**PROJECT: Town of Ridgeland Water and Sewer Resiliency Improvements
TOR-2023-02**

ADDENDUM: Two (2)

Town of Ridgeland Water and Sewer Resiliency Improvements (TOR 2023-02)

DRAWING NUMBER
E10.2

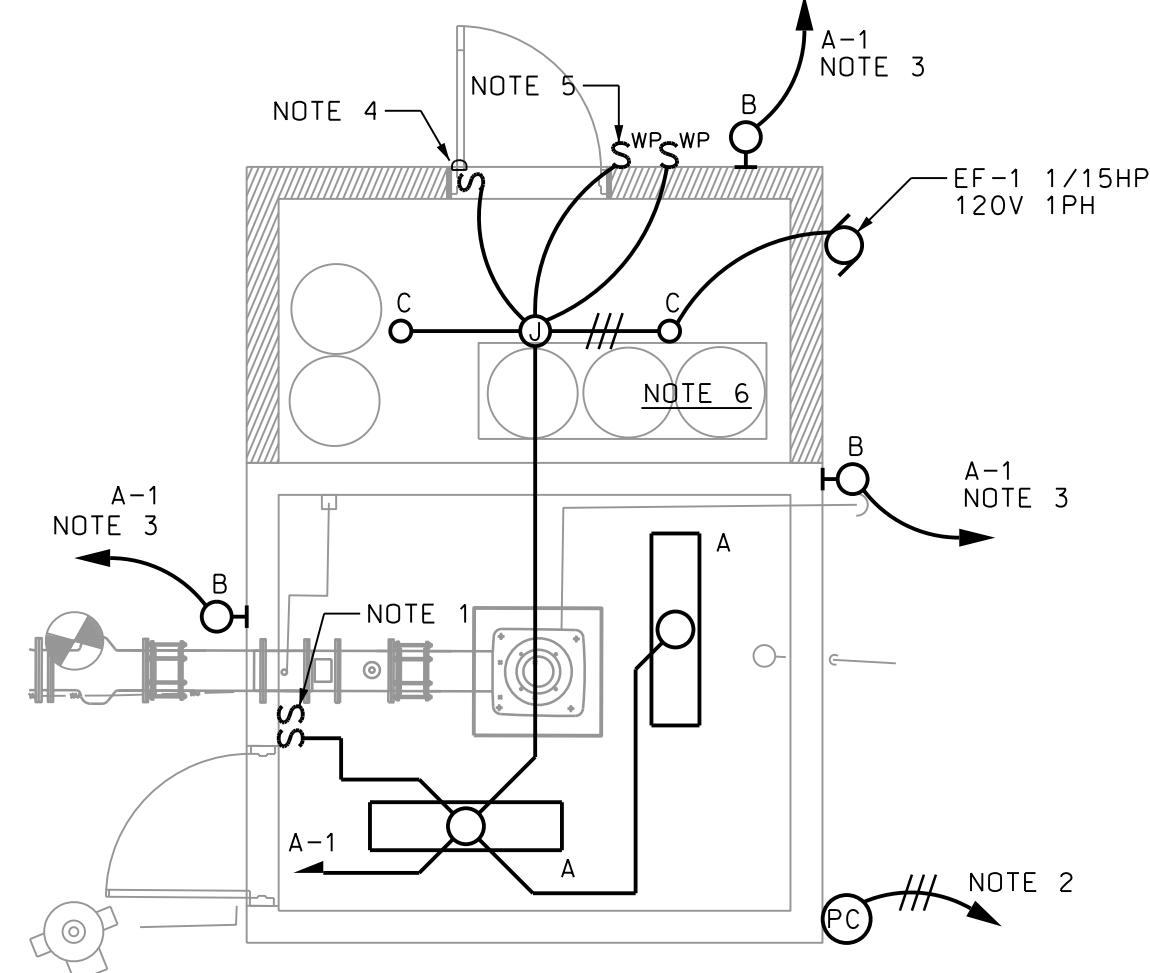
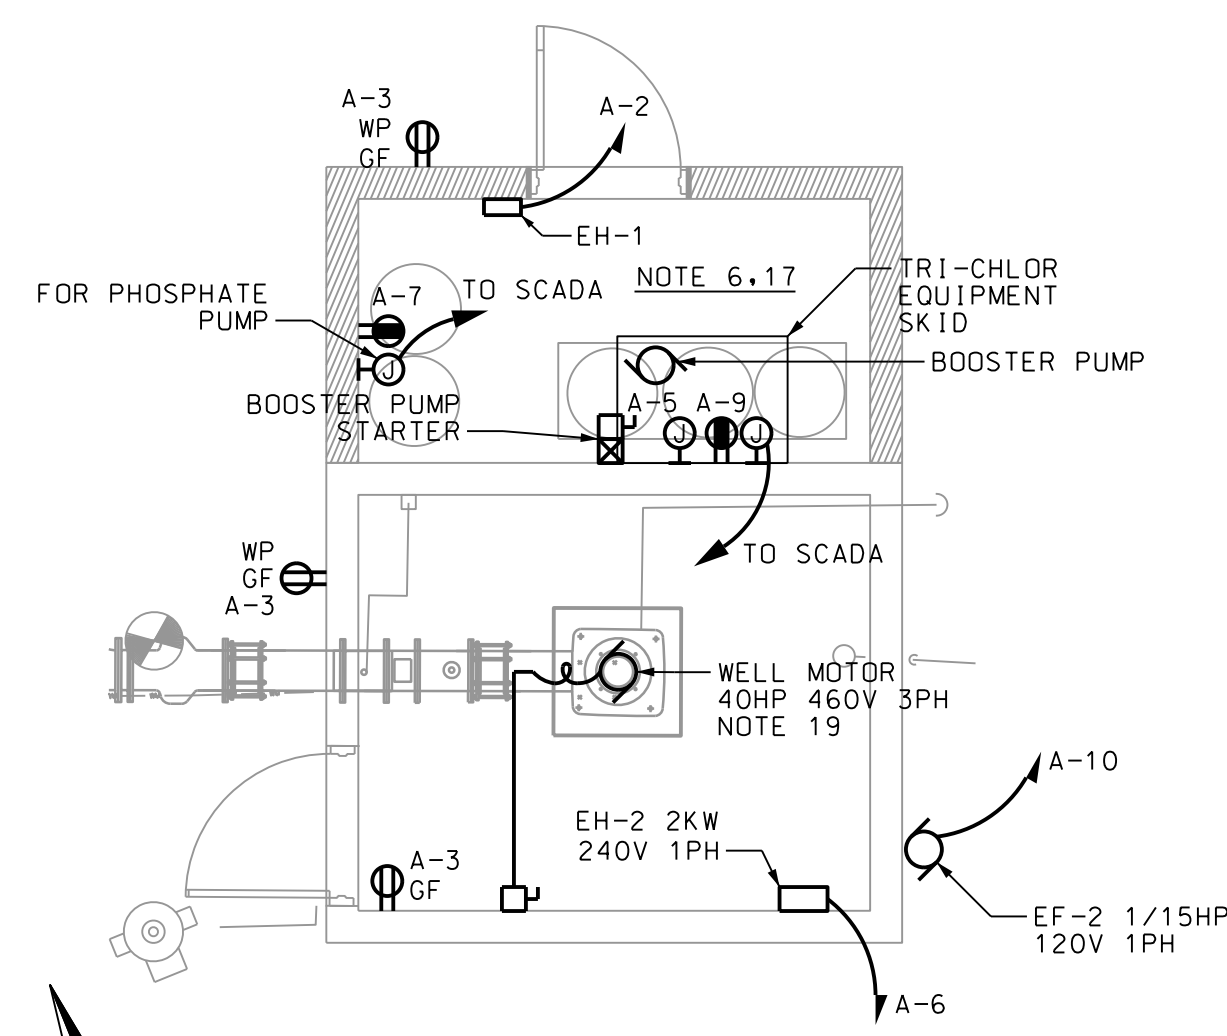
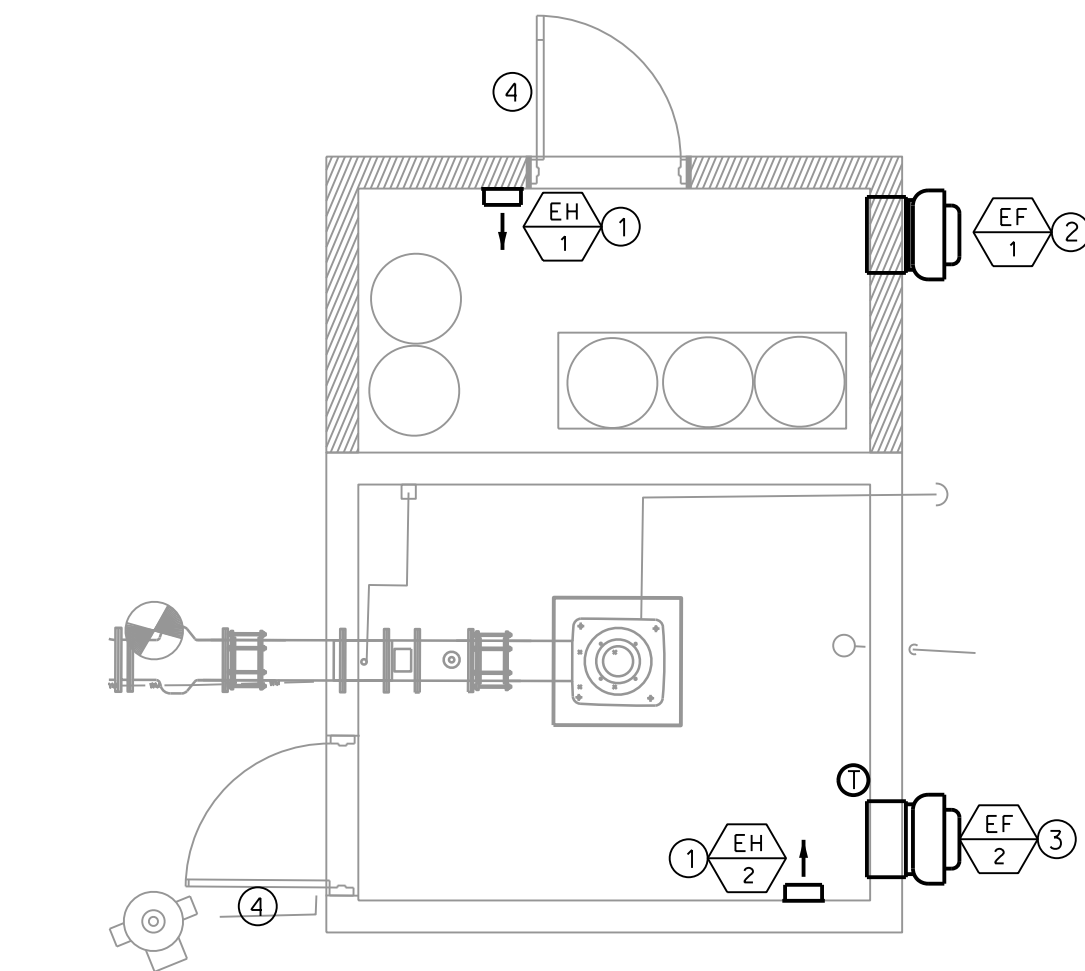
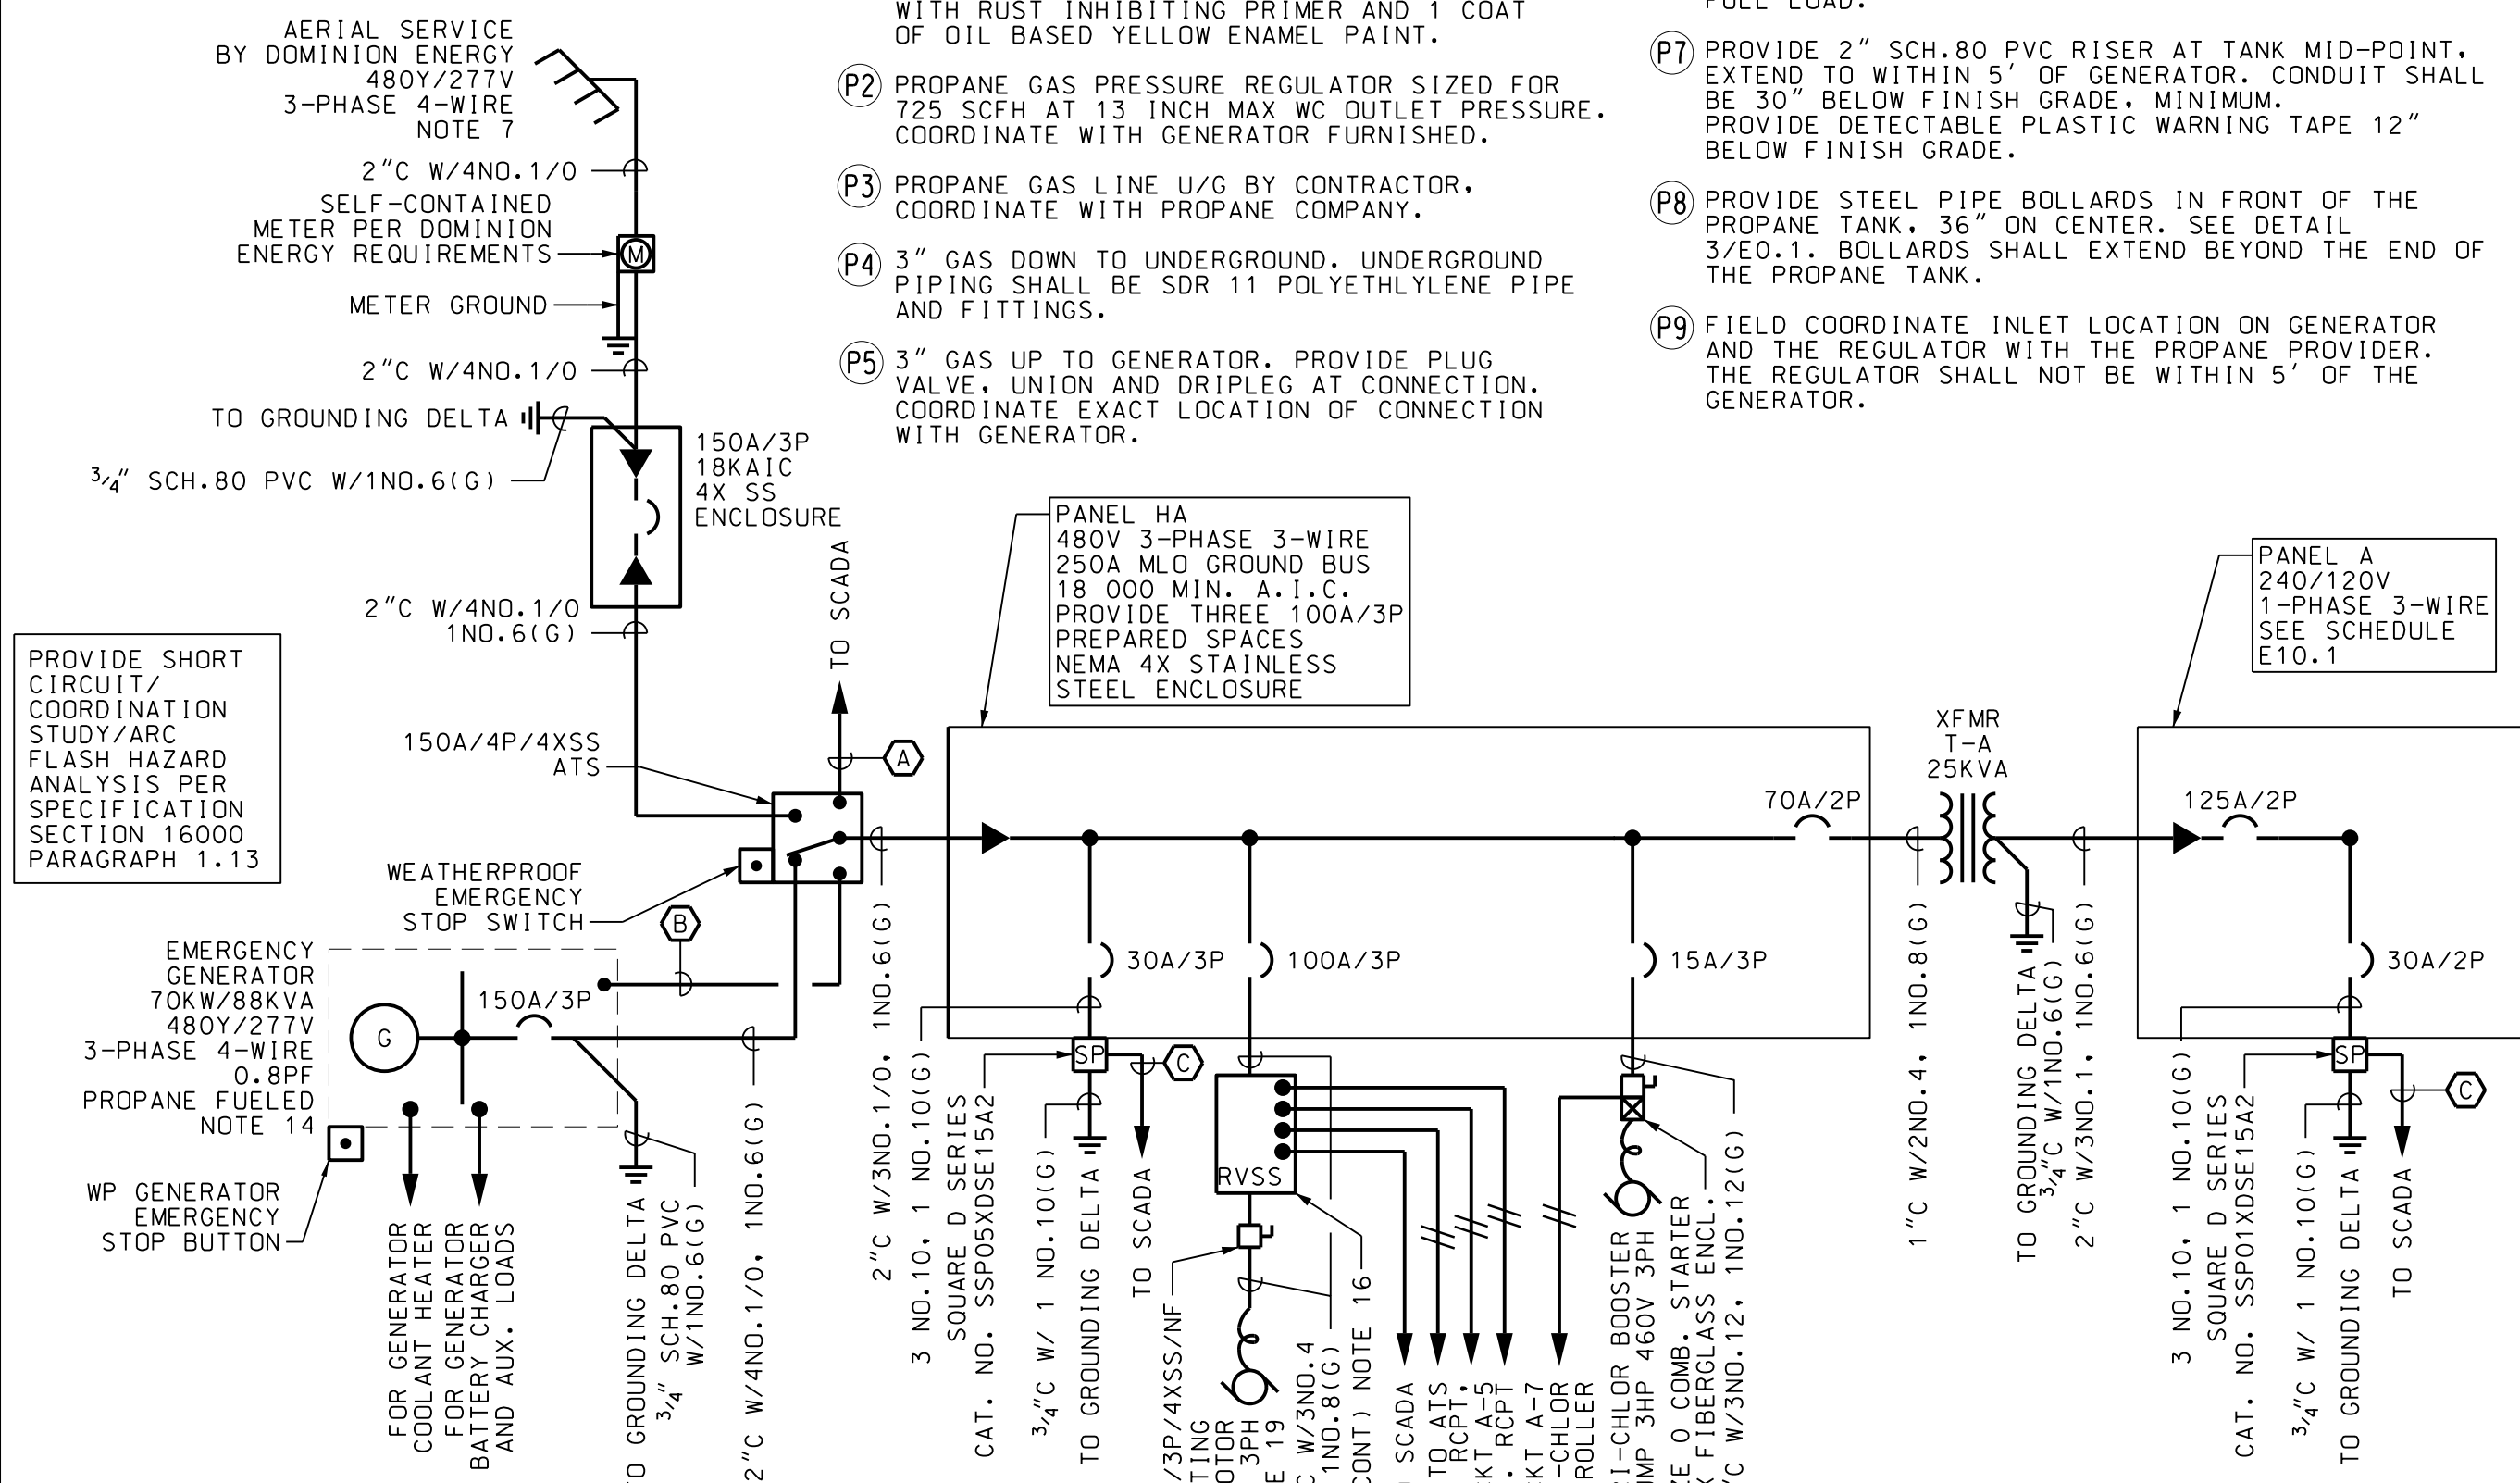
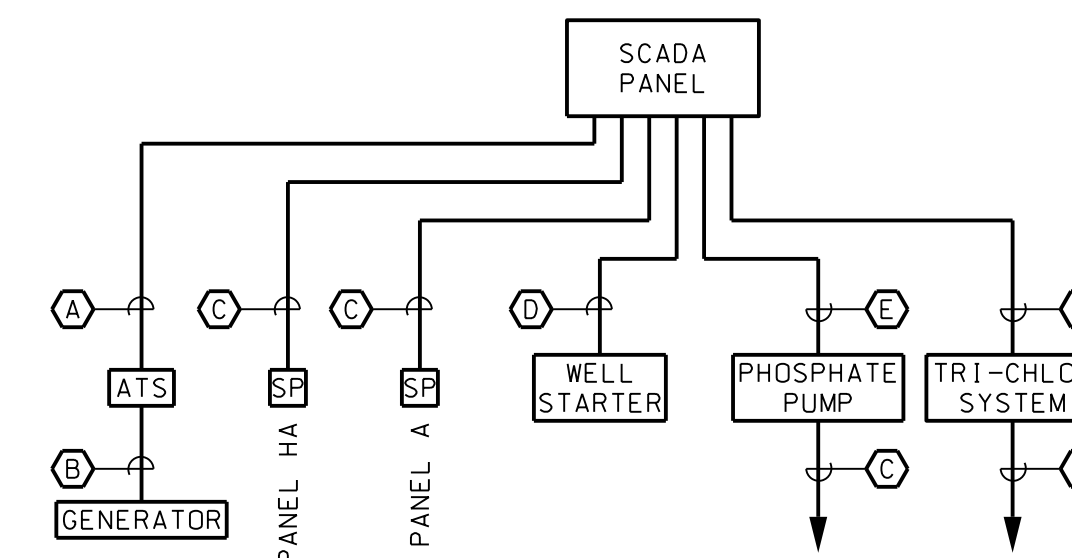
- a. Part III: Well Site 2 Improvements
 - i. E10.1 and E10.2: Electrical improvements updates to address chemical treatment system modifications.
